# ADDENDUM NO. 3

**August 13, 2026**

Perry Township Schools:
Southport High School Addition & Renovation Phase 2 (Classroom Addition and Athletic Renovations)
971 E. Banta Road
Indianapolis, IN 46227

## 4 CORRIDOR O200 RAMP ELEVATION

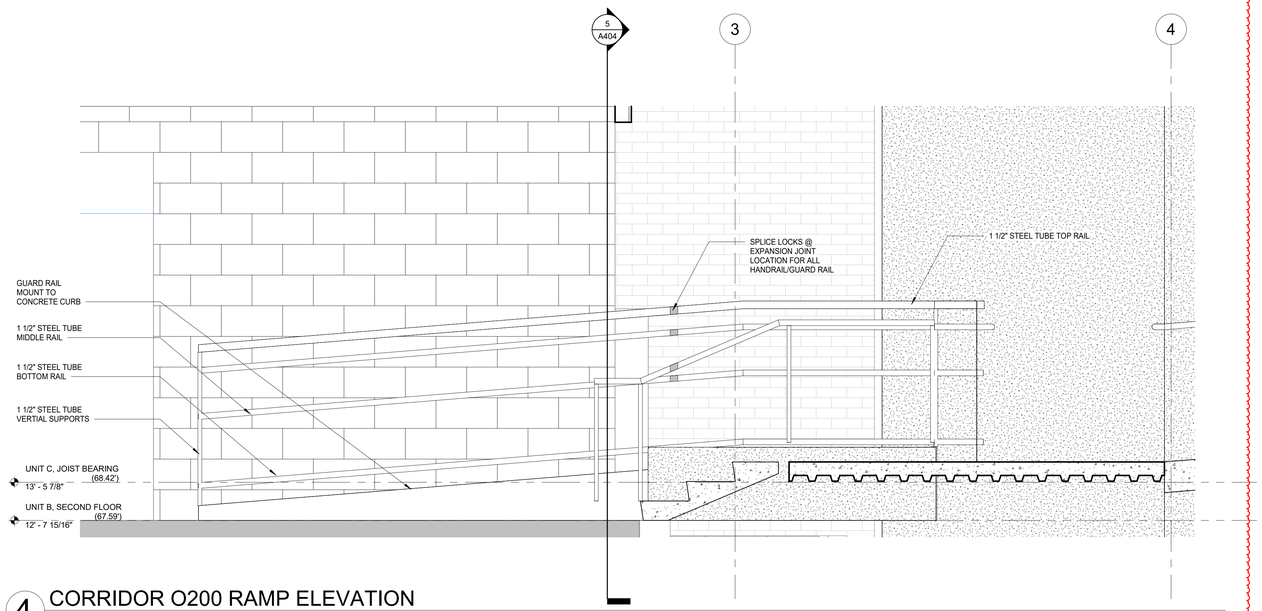
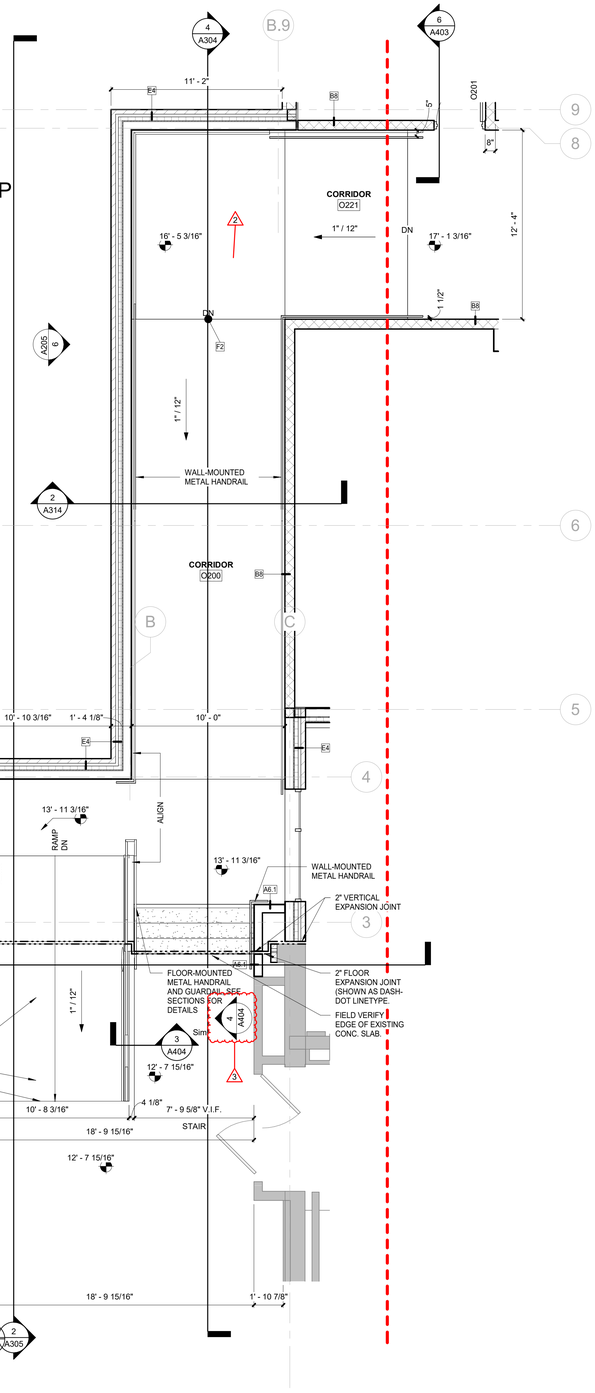
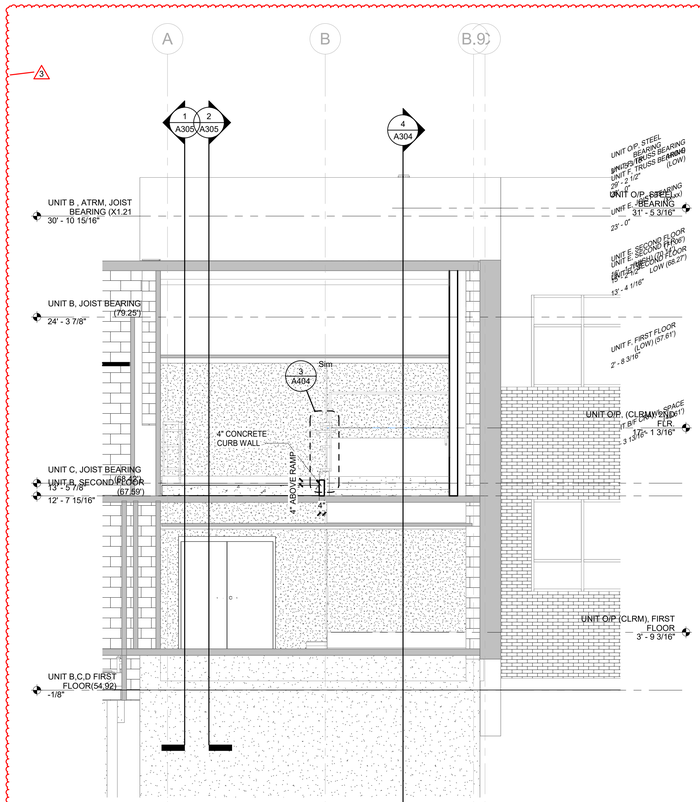
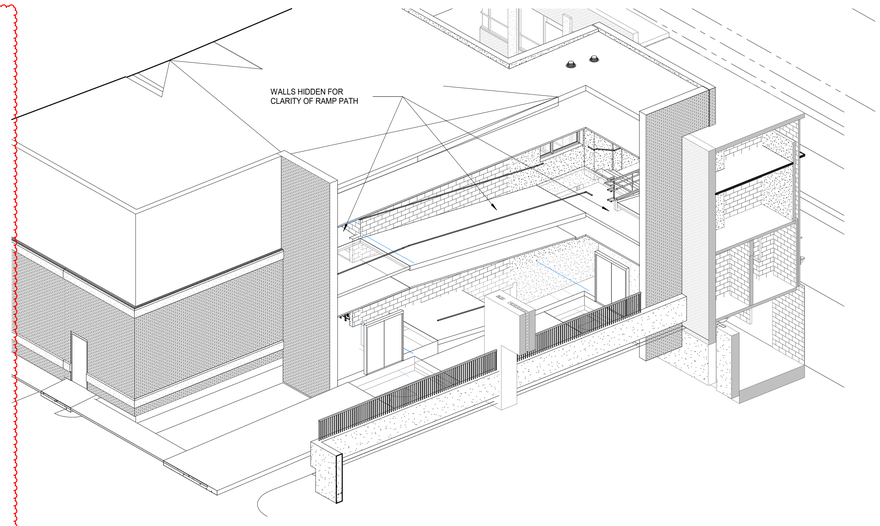
Change:
    - Section 3 notation
    - Add elevation for clarity of ramp
    - Add section.

PD104

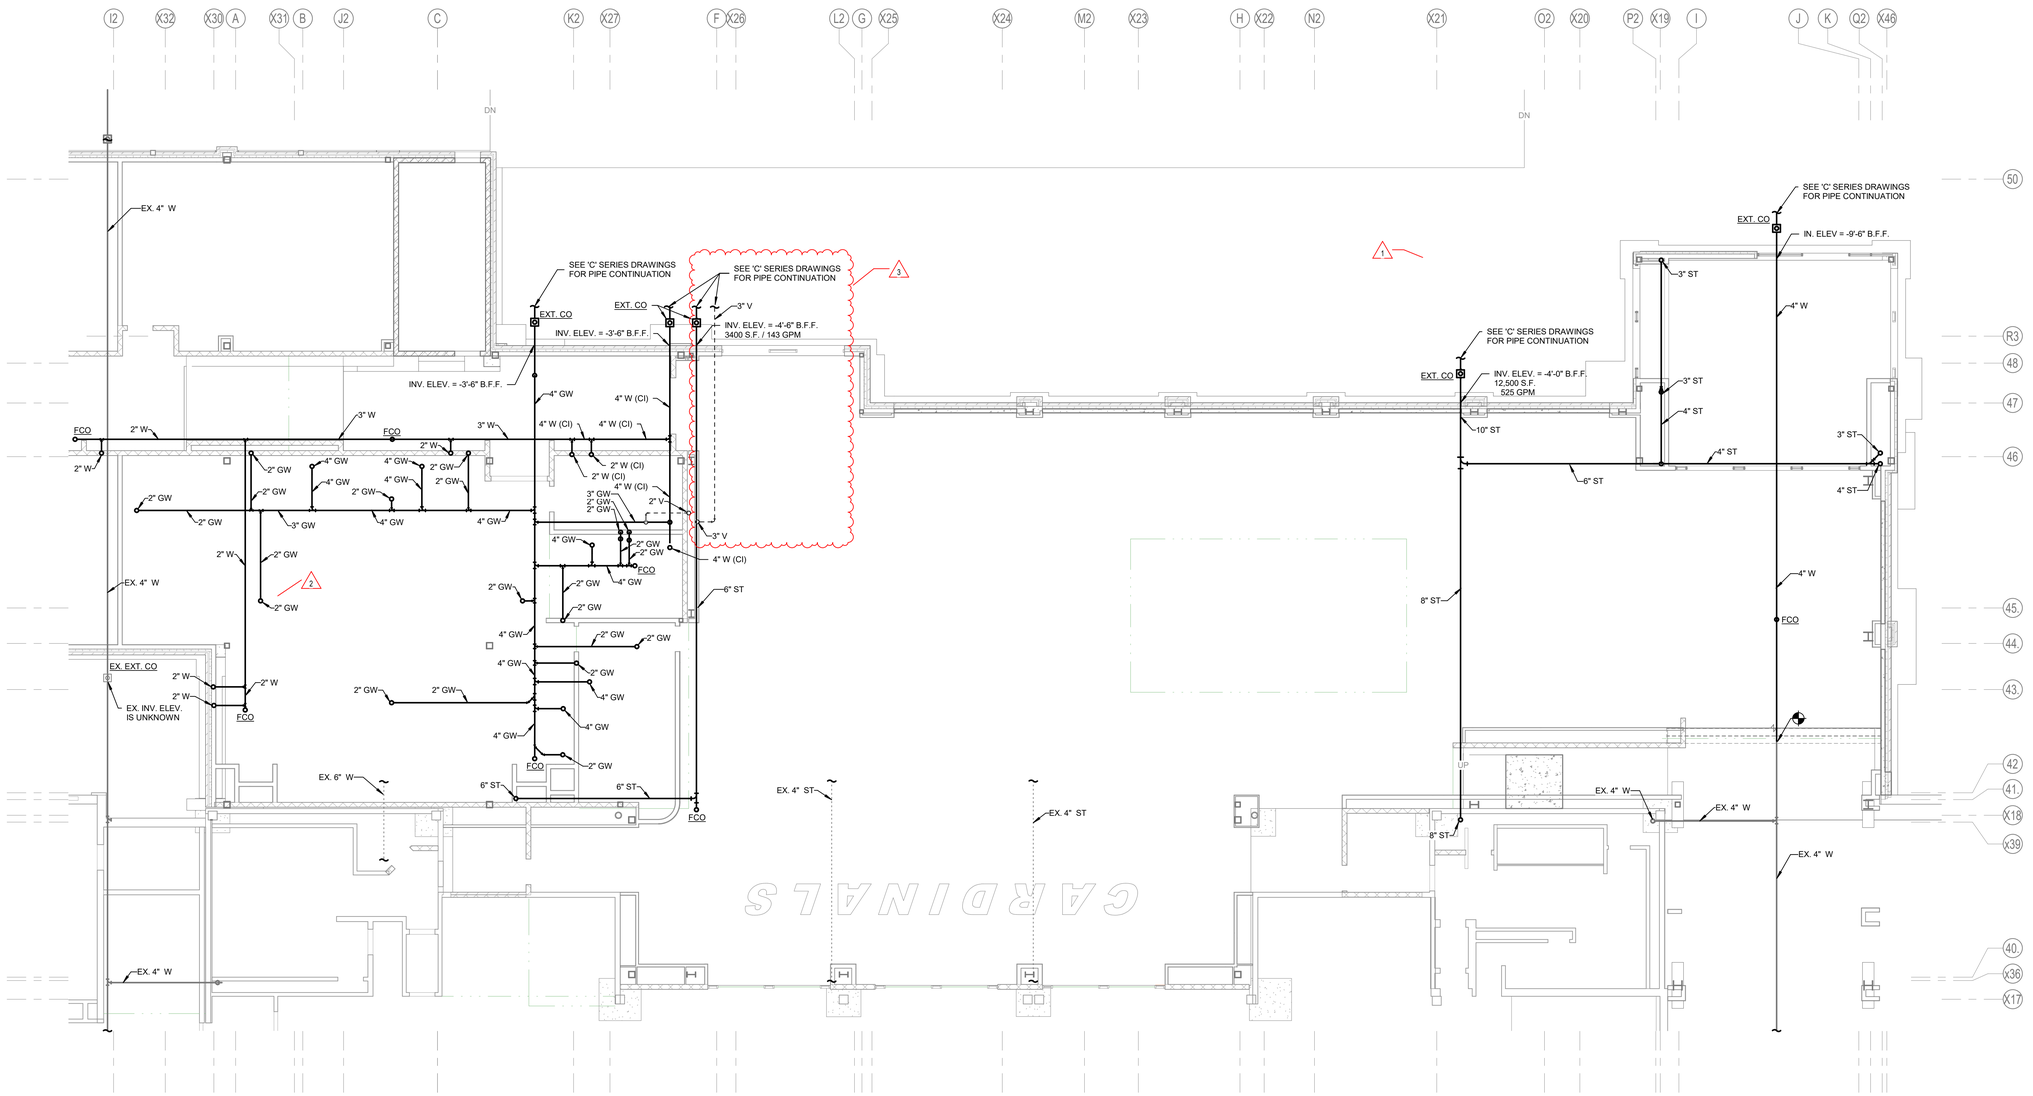
Change: See revised piping in existing Laundry Room K150.

PP102

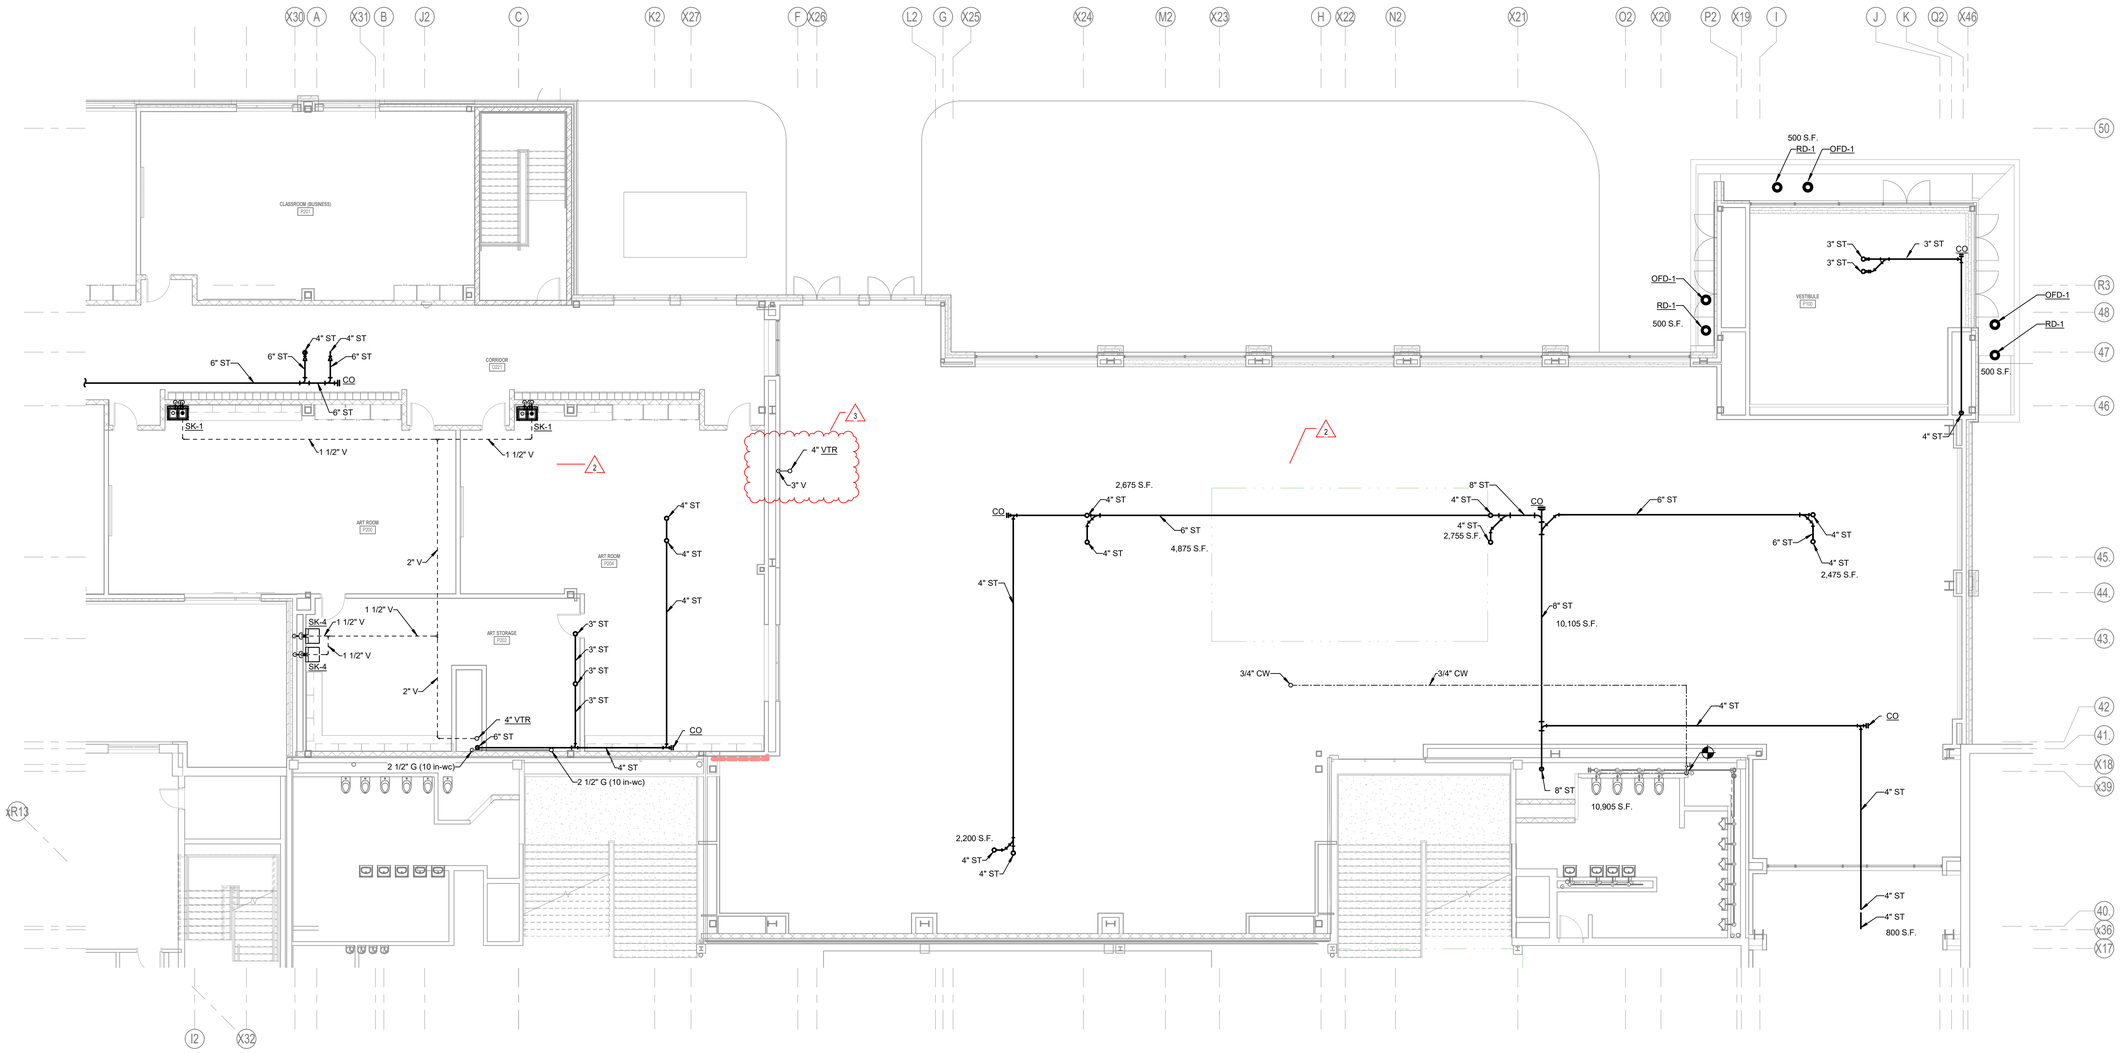
Change: See revised piping in Laundry Room K150.

ELECTRICAL ONE-LINE DIAGRAMS

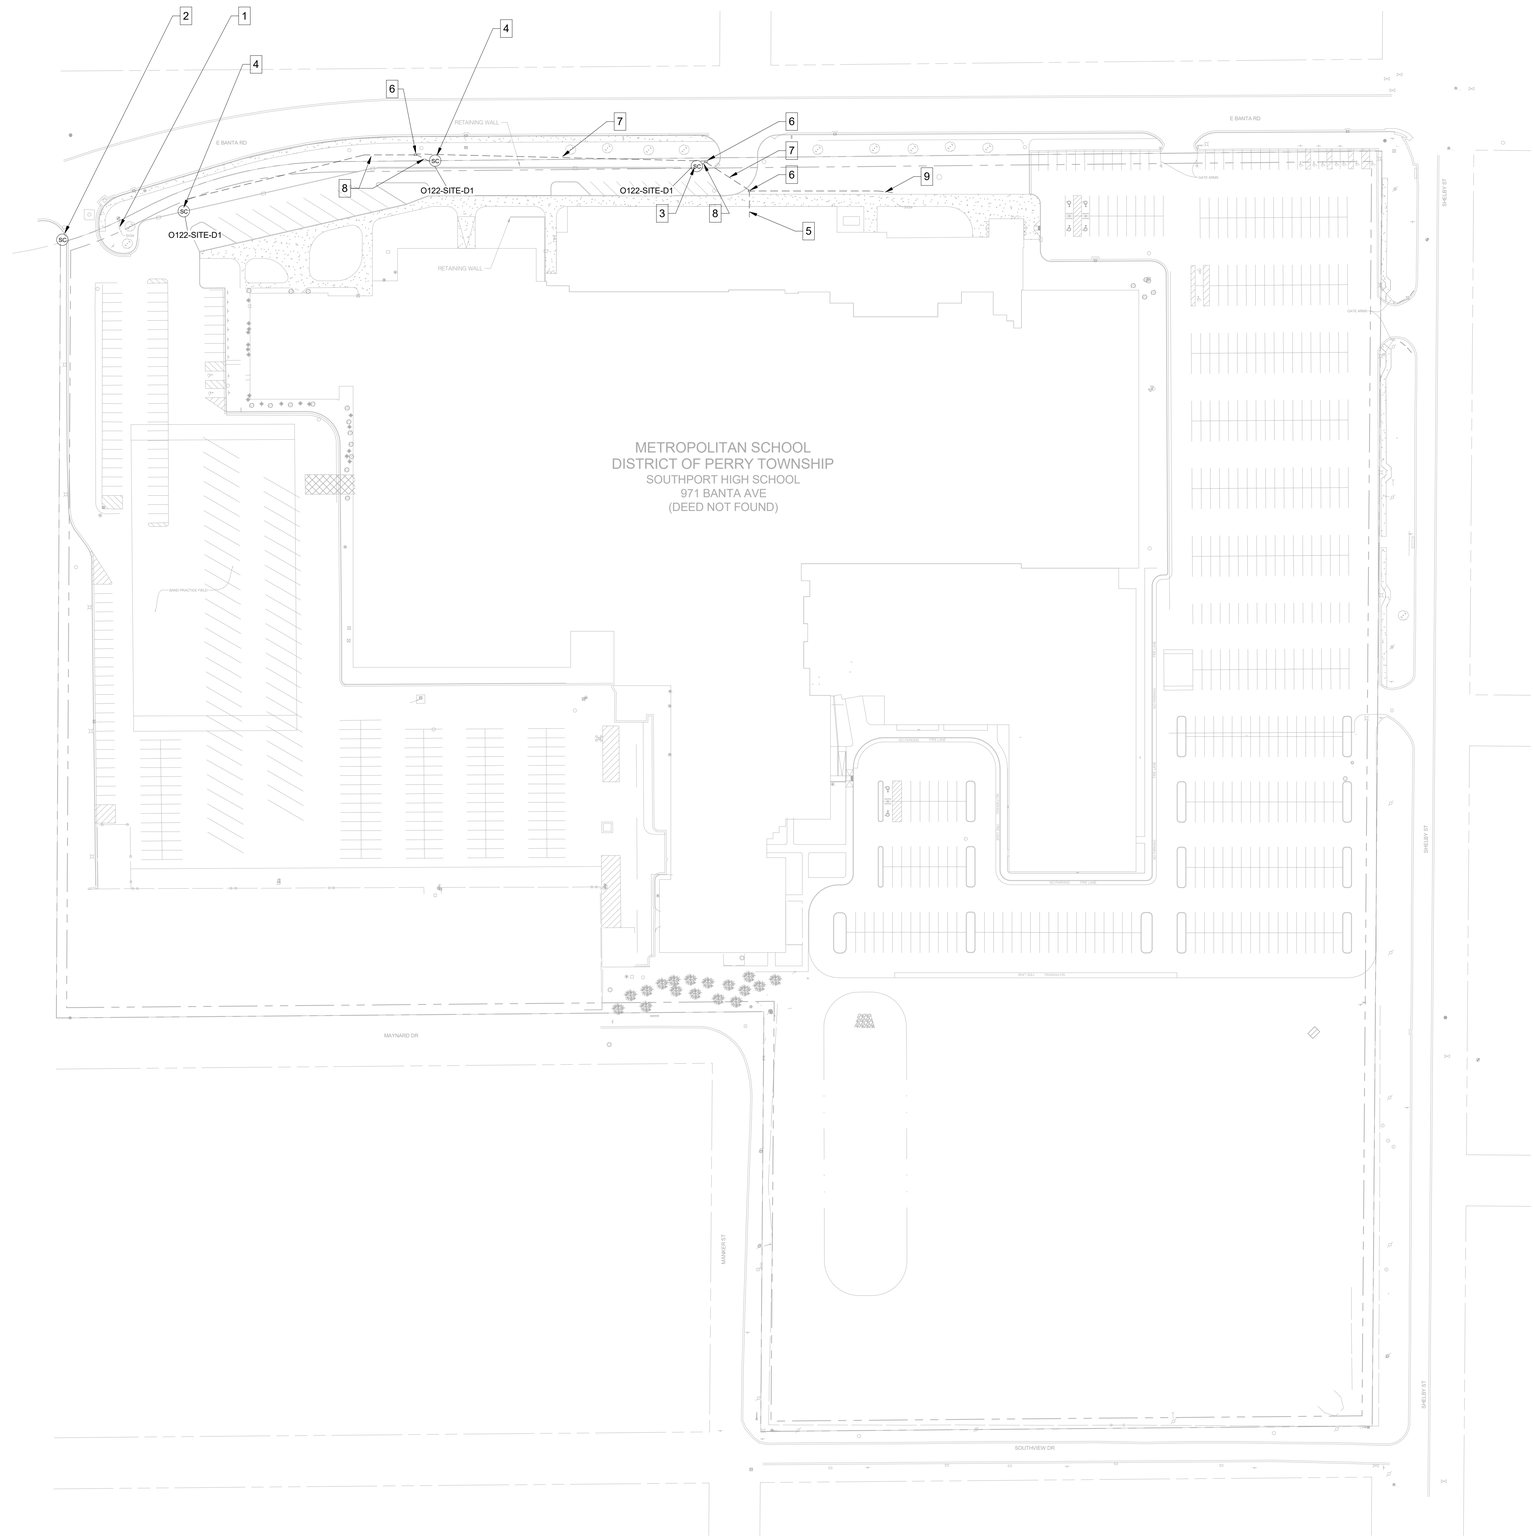
Change: Increased circuit breaker and feeder size for panelboard 2HN7.
